# CITY OF PORTLAND BUILDING PERMIT

Located At **86 BALLPARK DR**

Job ID: **2012-04-3809-SF**

has permission to New Single Family Residence with an attached garage.

**SITE PLAN**  
OF  
LOT 9 - 86 BALLPARK DRIVE, PORTLAND, MAINE  
MADE FOR  
**BOUFFARD & McFARLAND BUILDERS**  
97 HICKORY DRIVE, AUBURN, MAINE 04210

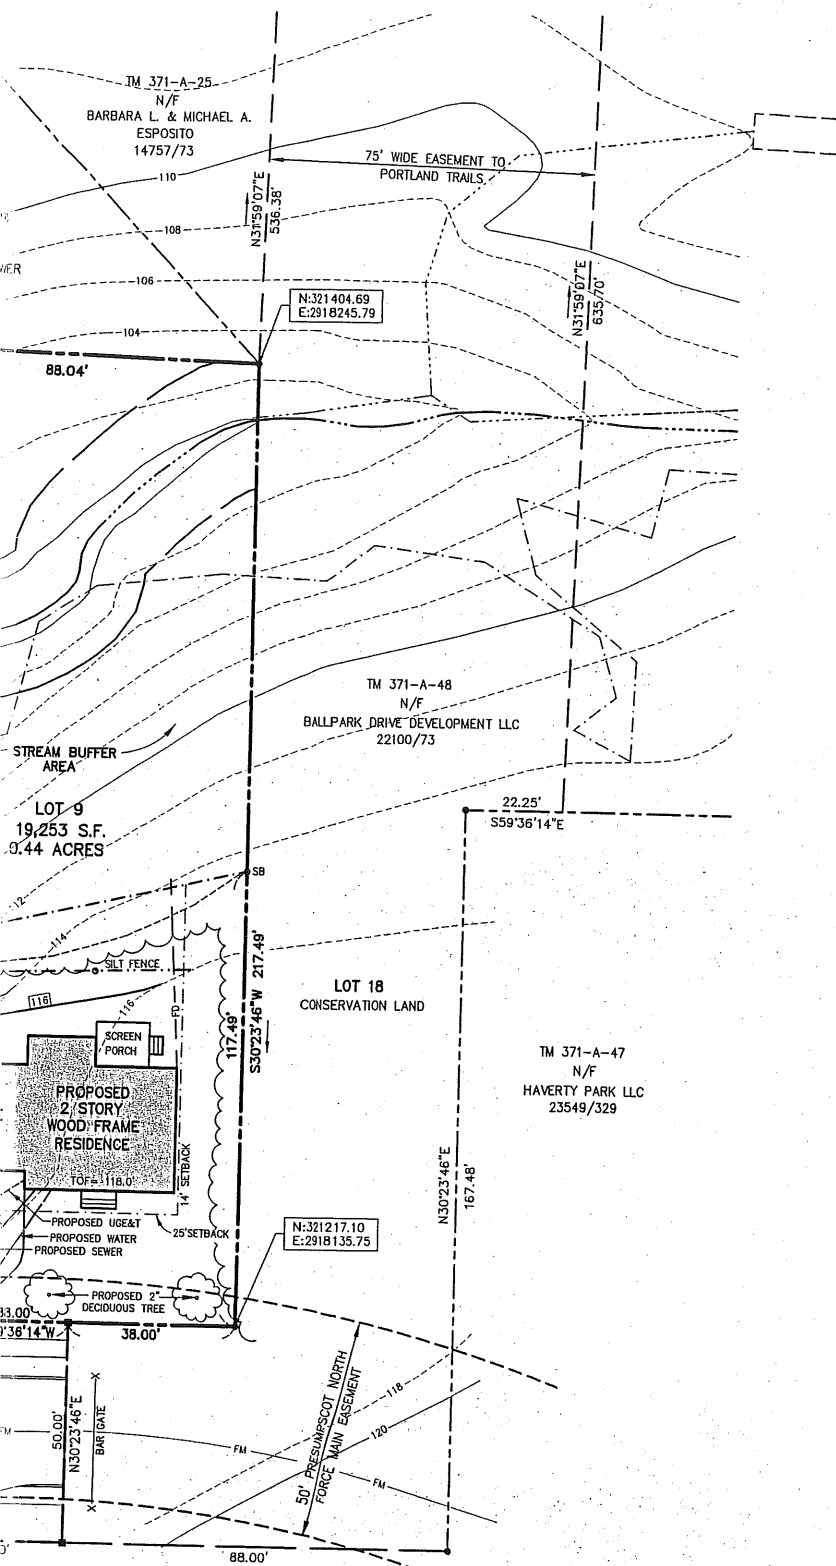
REV. 3	5/17/2012	ADD BULKHEAD			
REV. 2	5/14/2012	ADD TREE TO BE REMOVED			
REV. 1	5/2/2012	REVISED PER CITY COMMENTS			
<b>SITE PLAN</b> OF LOT 9 - 86 BALLPARK DRIVE, PORTLAND, MAINE MADE FOR <b>BOUFFARD &amp; McFARLAND BUILDERS</b> 97 HICKORY DRIVE, AUBURN, MAINE 04210 <b>OWEN HASKELL, INC.</b> 380 U.S. ROUTE ONE, FAIRBOUTH, ME 04105 (207) 774-0484 PROFESSIONAL LAND SURVEYORS					
Drawn By	OHI	Date	APRIL 12, 2012	Job No.	2012-055P
Trace By	JLW	Scale	1" = 20'	Draw. No.	1
Check By	JWS	Book No.	1010

Please find attached a revised (bulkhead added) pdf of the Site Plan for 86 Ballpark Drive.
